**Seattle
Public
Utilities**

Seattle Design Commission Presentation: October 7, 2021

Ballard Pump Station

Schematic design recommendations: SPU responses

Urban Tree Farm

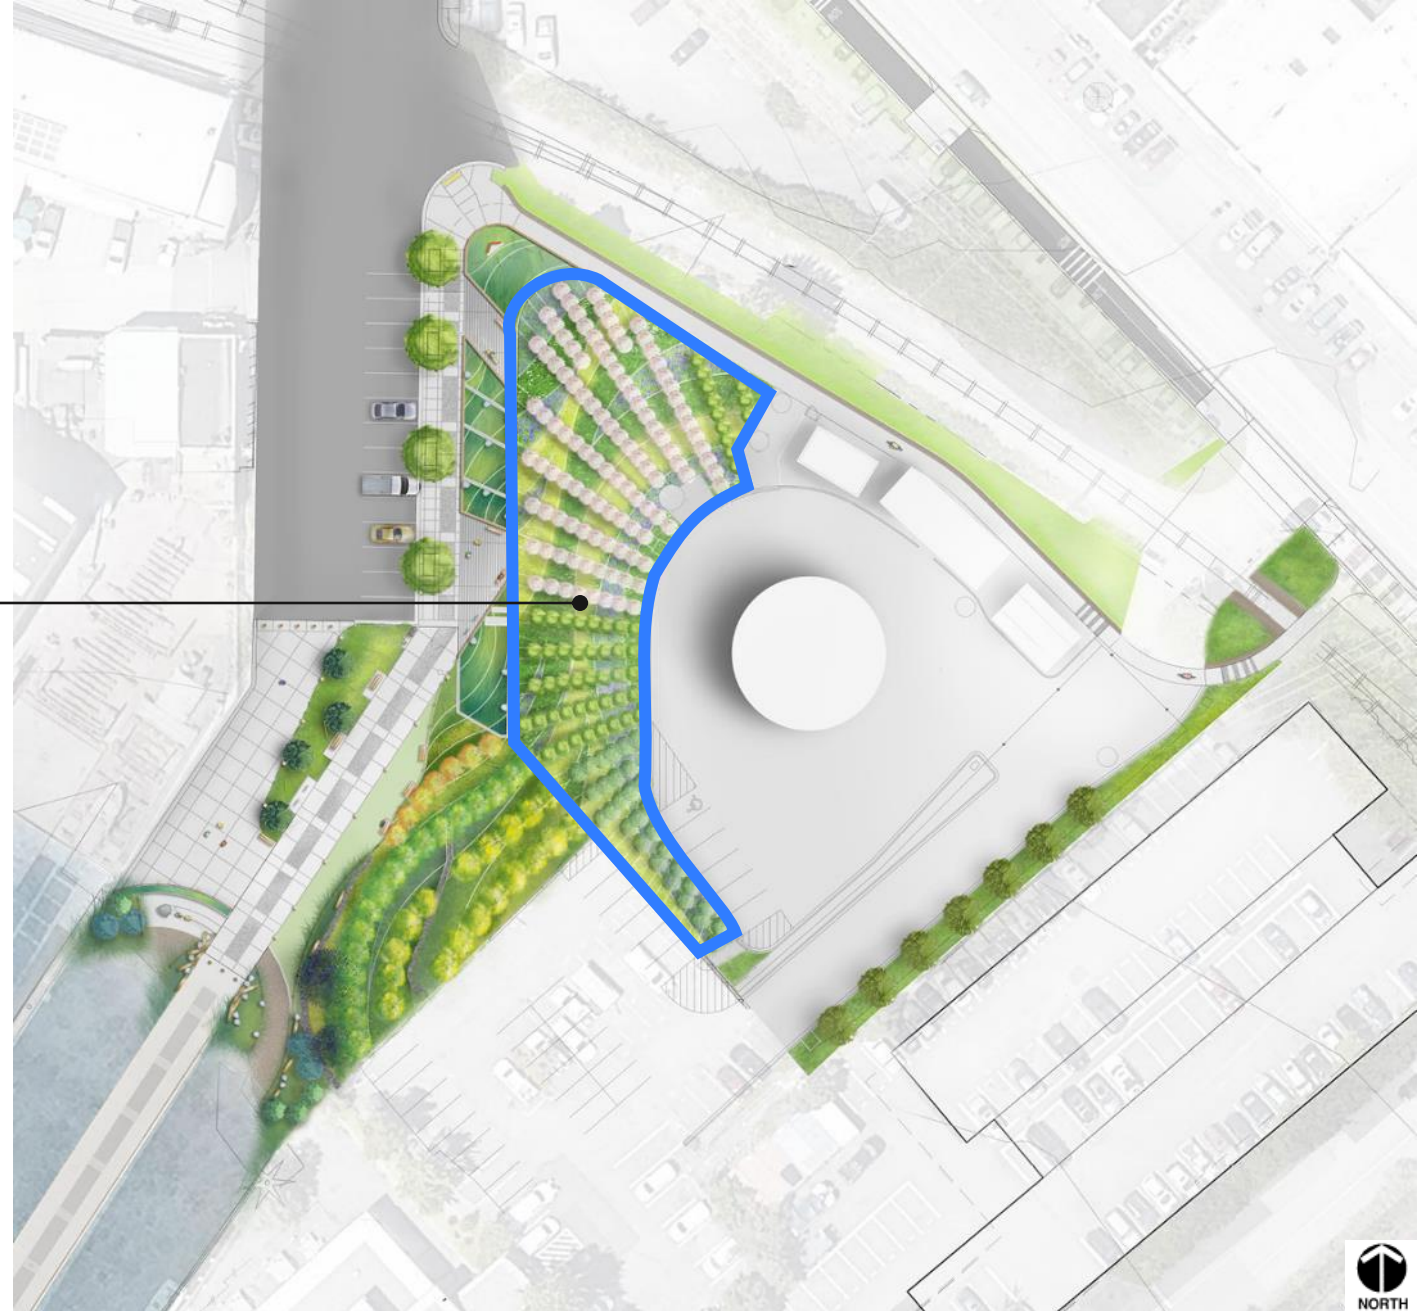
3. **Maximize public access** to the water, especially for underserved communities, as soon as possible.
4. Consider **relocating the fence eastward** and/or **lowering it** to allow more public interaction (visible or physical) with the tree farm.

- Coordinated with SDOT Urban Forestry on species
- Narrowed down to 7 tree species selected for diversity of size, urban tolerance, and aesthetics
- O&M manual developed for contractor use

24th ROW & GSI Design Details

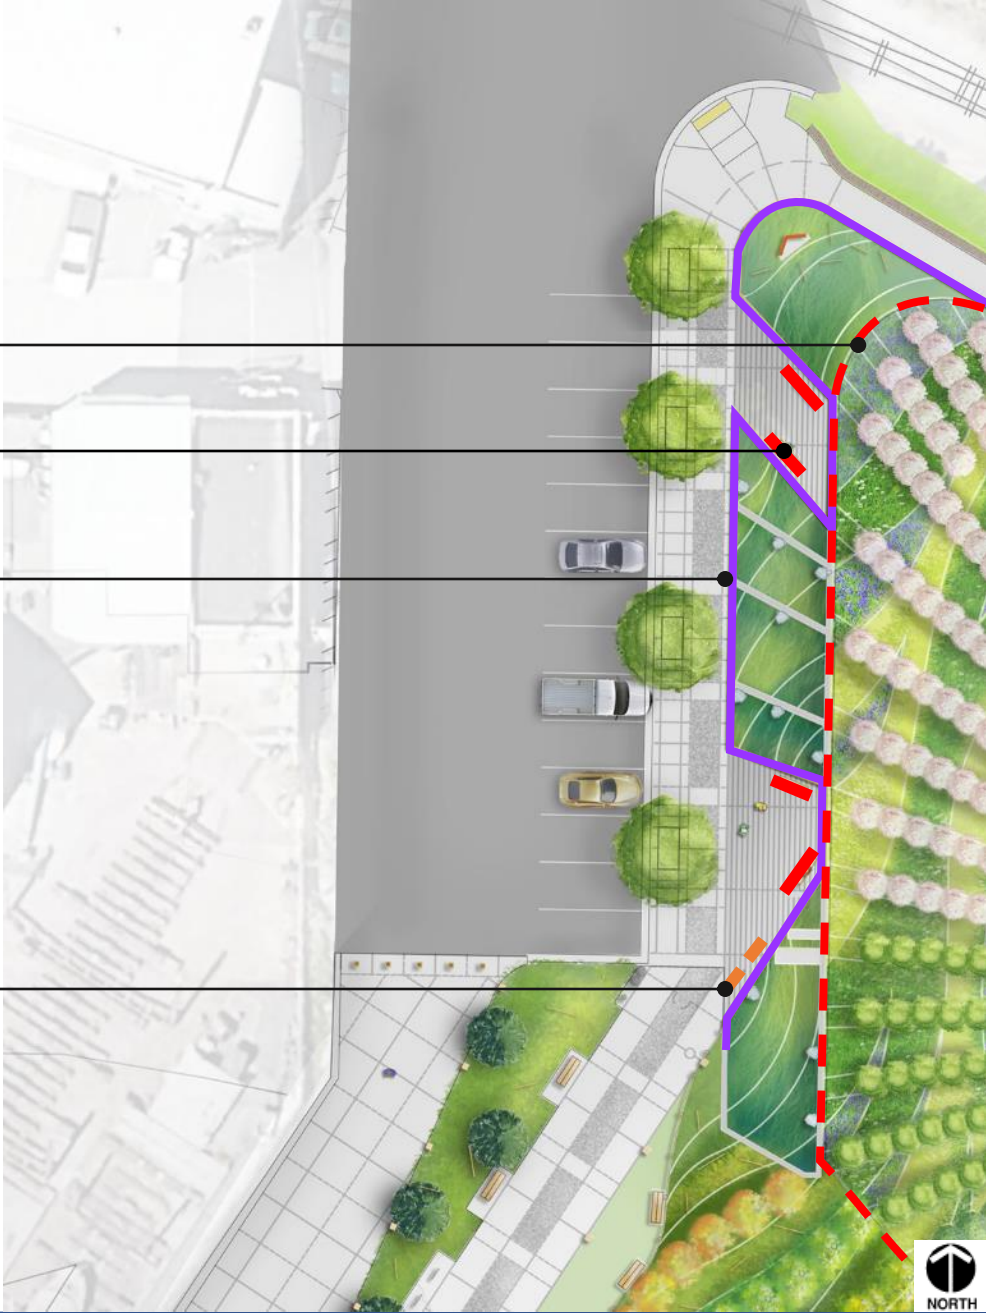
5. Thoroughly consider **parking needs** and maximize **pedestrian and recreational use** of the shoreline right of way. Provide for **temporary community programming**.
6. Consider providing more **amenities** that support full use of what will be a busy access point to the water, including bike parking, locking stations for kayaks / paddle boards, and sufficient trash and recycling areas.
7. Provide enough **seating with backs** and side rails to meet the needs of the older people in this community.

Large wood timber benches
(flexible to sit in all directions)

Bull rails with low lighting

Bike racks

Updates

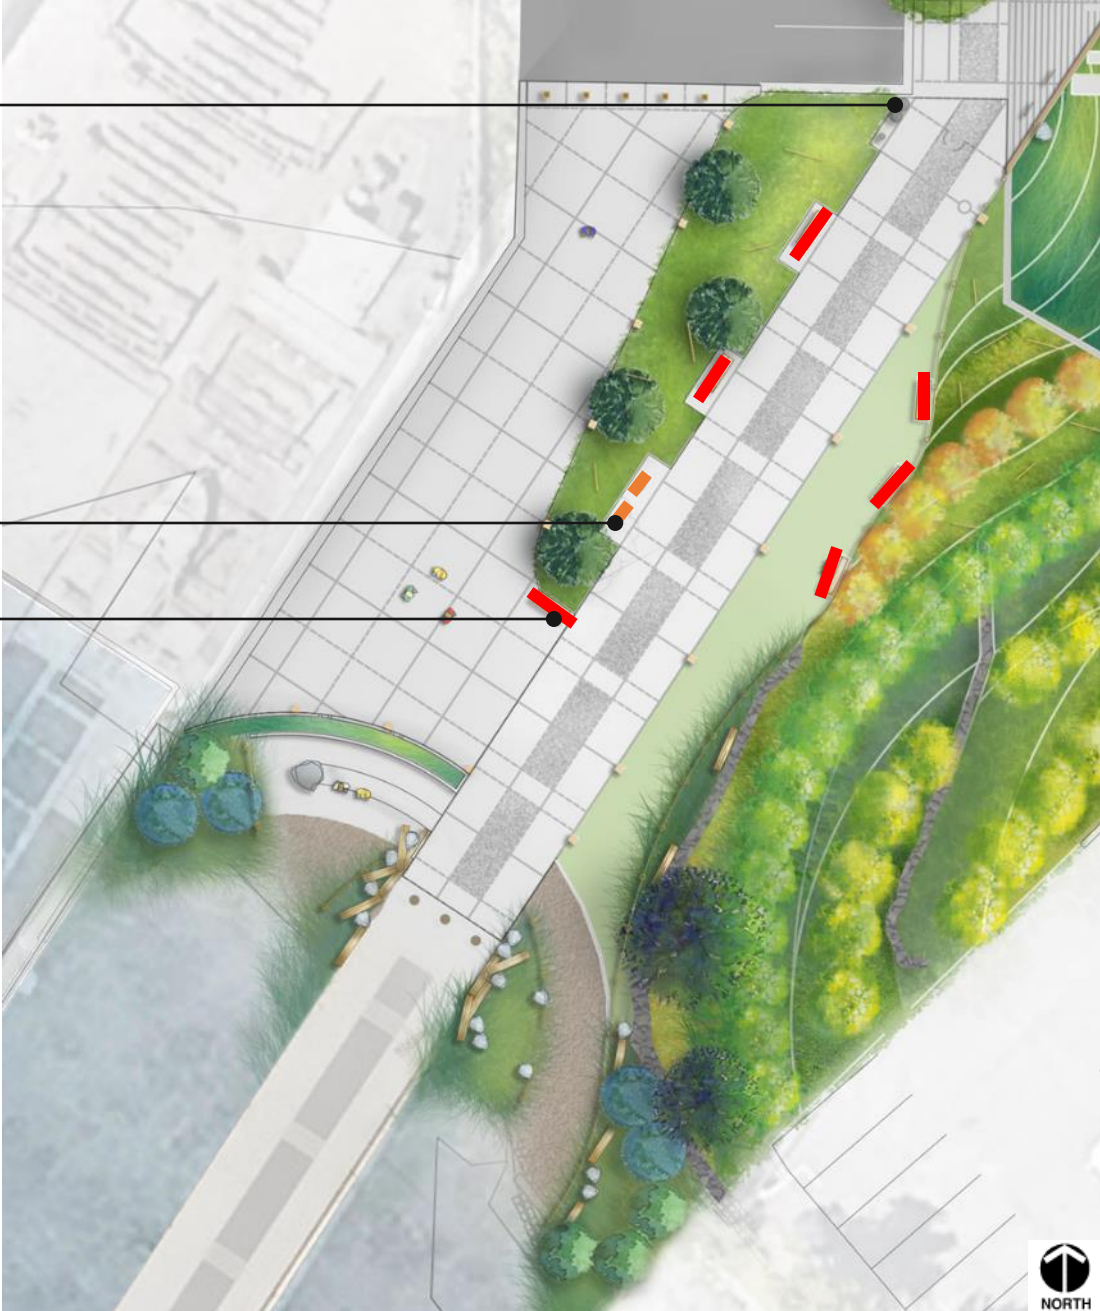
6. Consider providing more **amenities** that support full use of what will be a busy access point to the water, including bike parking, locking stations for kayaks / paddle boards, and sufficient trash and recycling areas.

7. Provide enough **seating with backs** and side rails to meet the needs of the older people in this community.
8. Consider **ambient light**, the multitiered and sided characteristic of the art, and the pedestrian perspective. Concern lighting might be **too bright for the surroundings** and could distract immensely from the art.

Trash, recycle, and dog waste receptacles

Bike racks

Large wood timber benches (with backs)

Schematic Design Recommendation

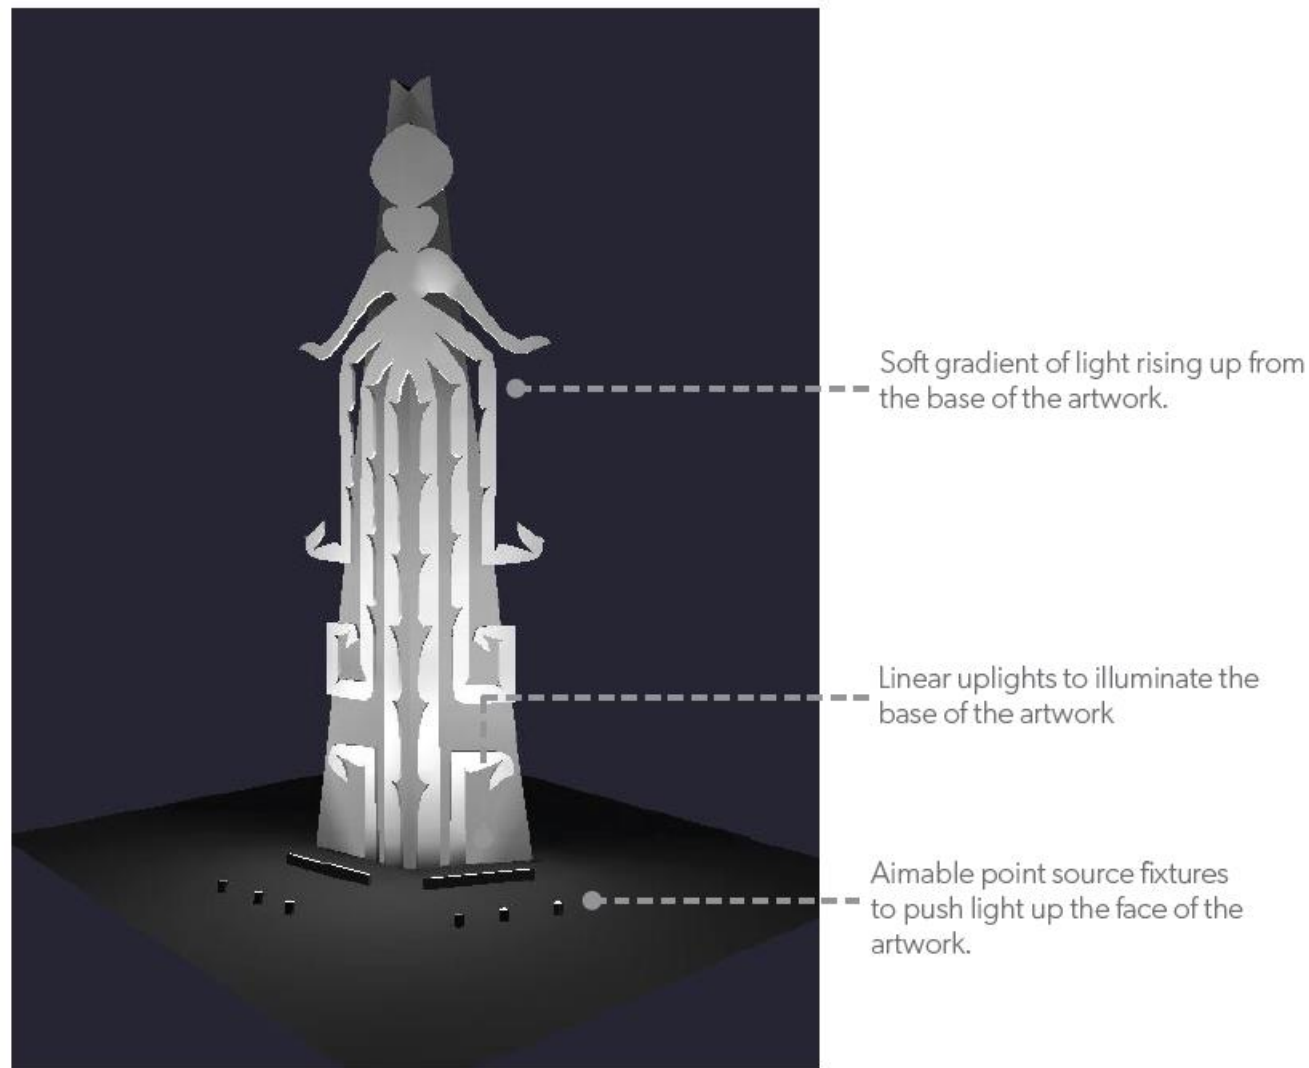
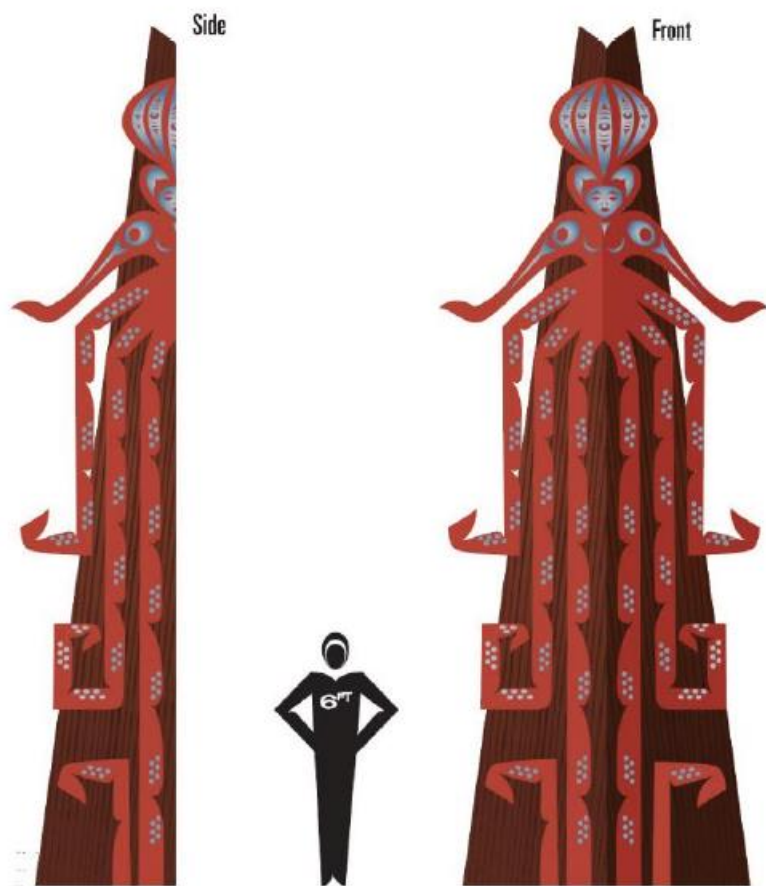
8. Consider **ambient light**, the multitiered and sided characteristic of the art, and the pedestrian perspective. Concern lighting might be **too bright for the surroundings** and could distract immensely from the art.

**Pedestrian
Fixture, 14' Pole**
UrbanScape LED

Bollard
Hess Linea
S 900

Uplight
BK Lighting
HP

Bench Light
Q-Tran

Linear Light
Q-Tran

"Firefly" Light
Q-Tran

FENCE AND ANCILLARY EQUIPMENT

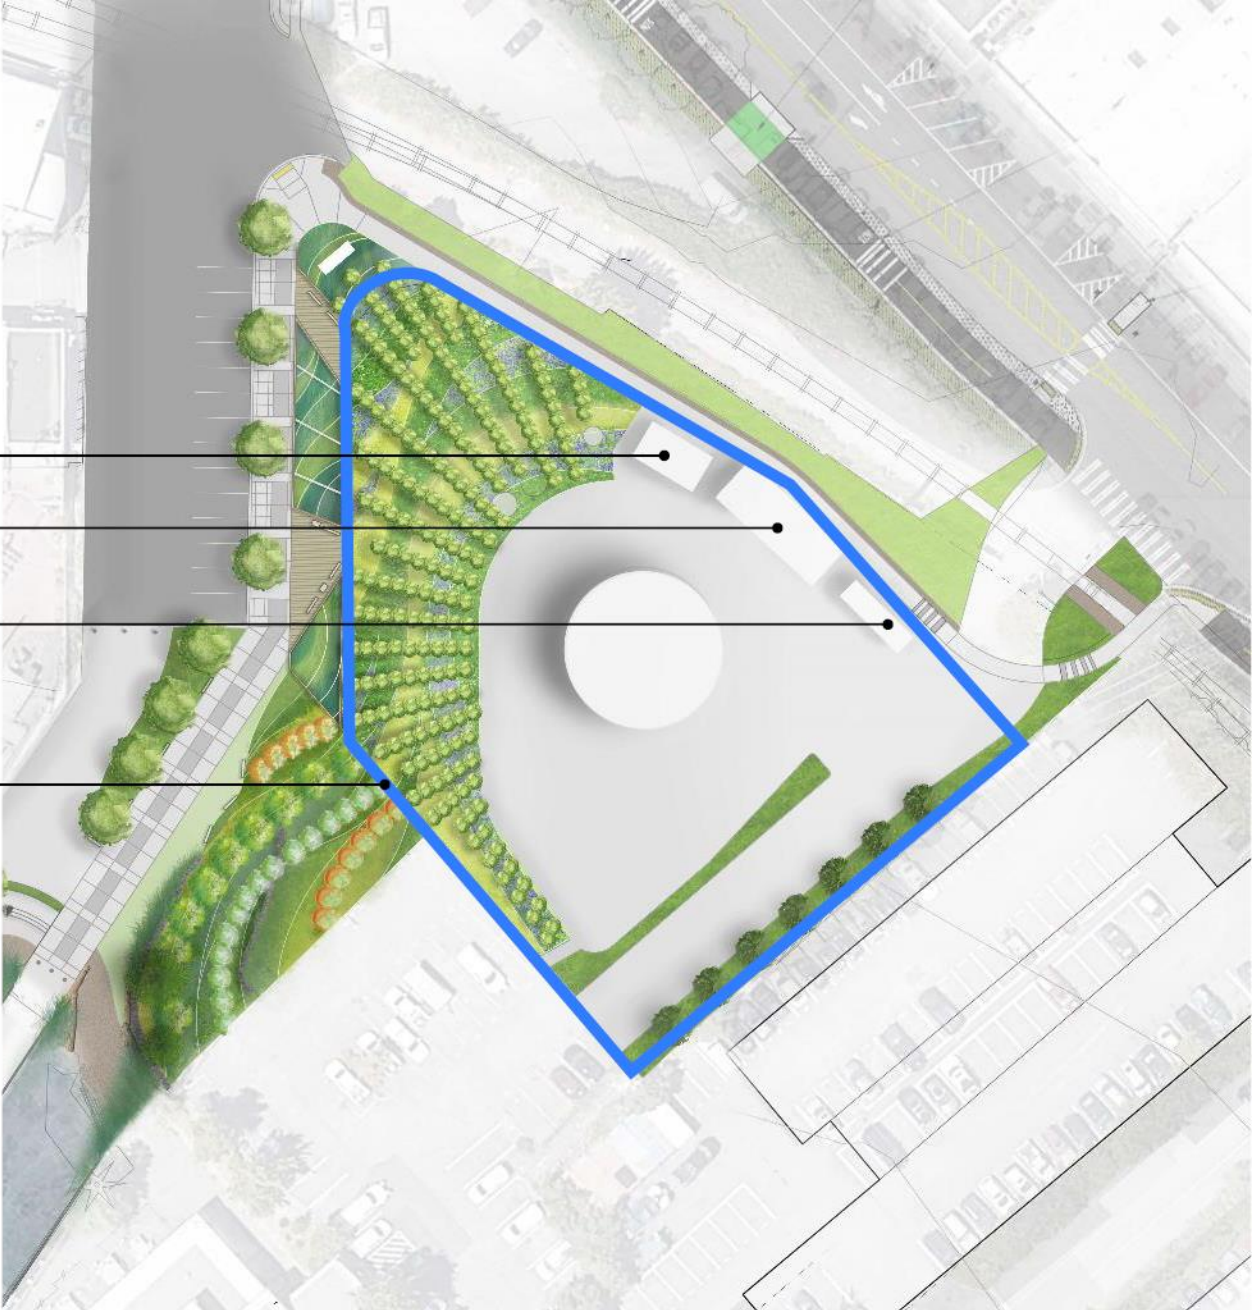
9. Consider a more **permeable, transparent material** for the fence.

SECURE PERIMETER AND ANCILLARY EQUIP.
